Planning Department  
Alan Varela, Director

January 30, 2026

**Re: Ellison Warehouse**  
**4000 Ellison St NE**  
**30-Day Temporary Certificate of Occupancy**  
**Transportation Development Final Inspection**  
Architect's Stamp dated 05-09-22 (D17-D074)  
Certification dated 01-28-2026  
TRANS-2026-00023

**1 SITE PLAN - TRAFFIC 1**  
1" = 30'-0"

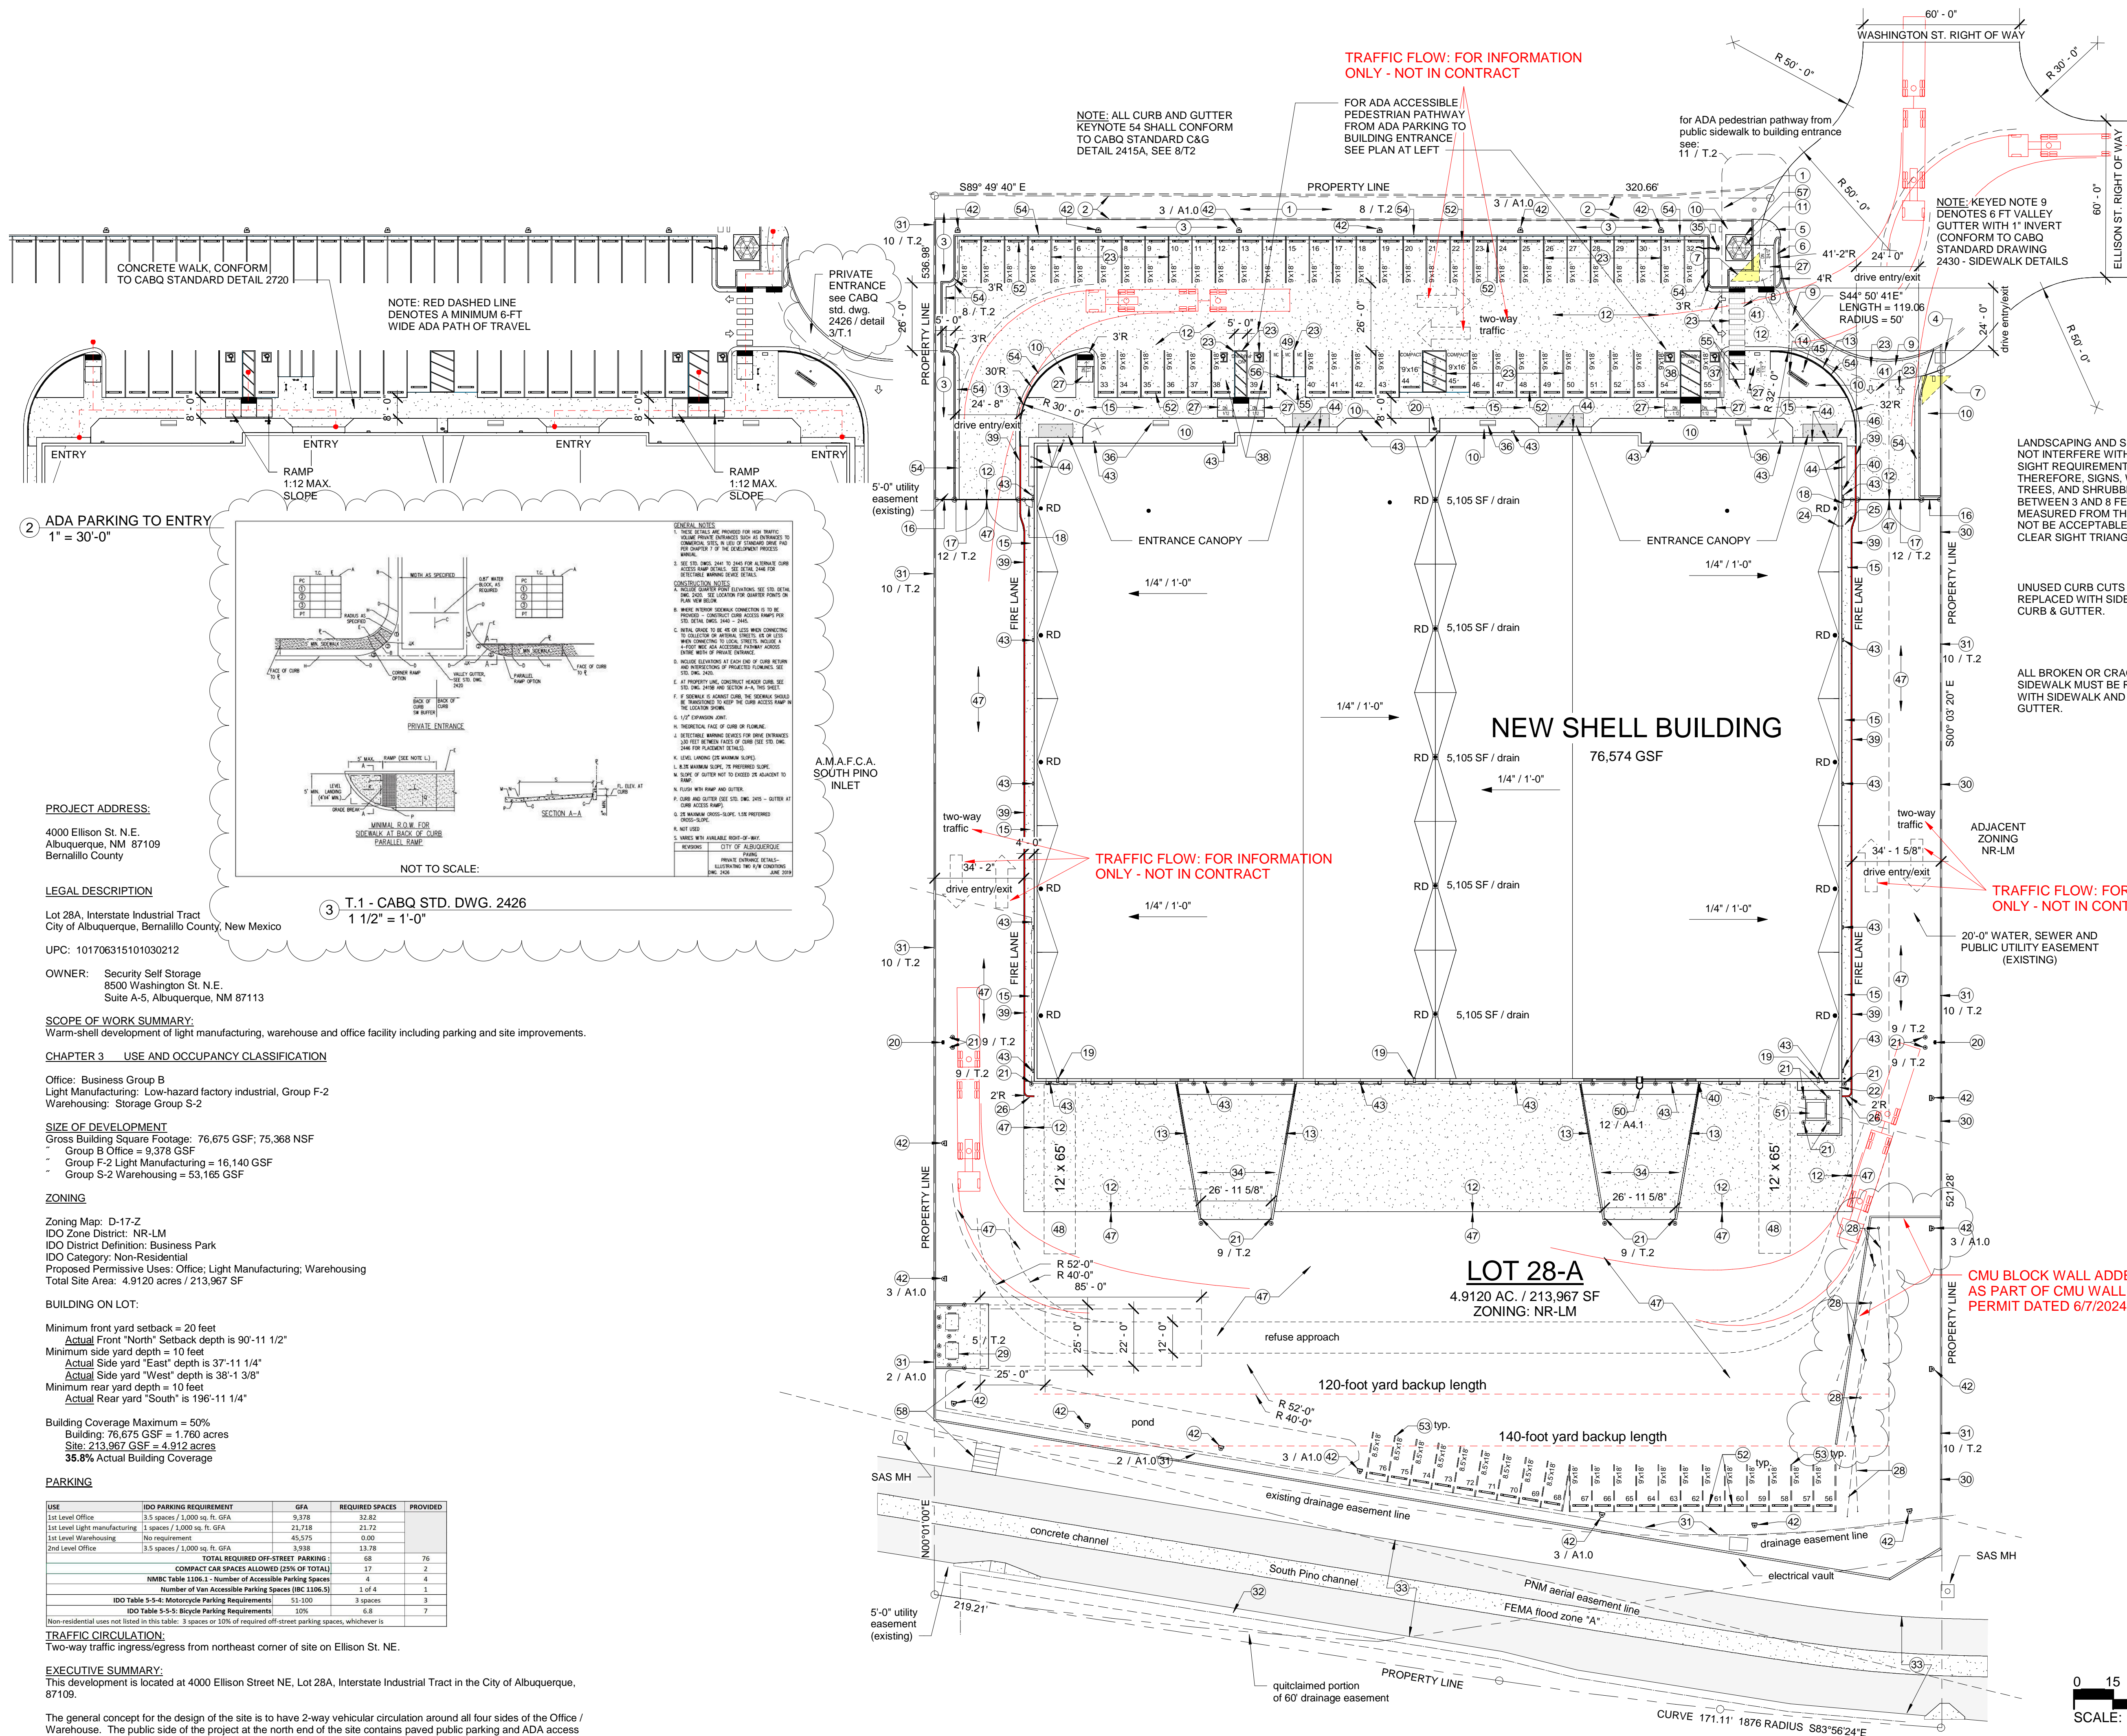
- A sidewalk easement will be needed prior to Certificate of Occupancy to incorporate the ADA pathway with a maximum 2% cross-slope along frontage of property.

Once this correction is complete, email the sidewalk easement to [malnajjar@cabq.gov](mailto:malnajjar@cabq.gov) for release of Final CO.
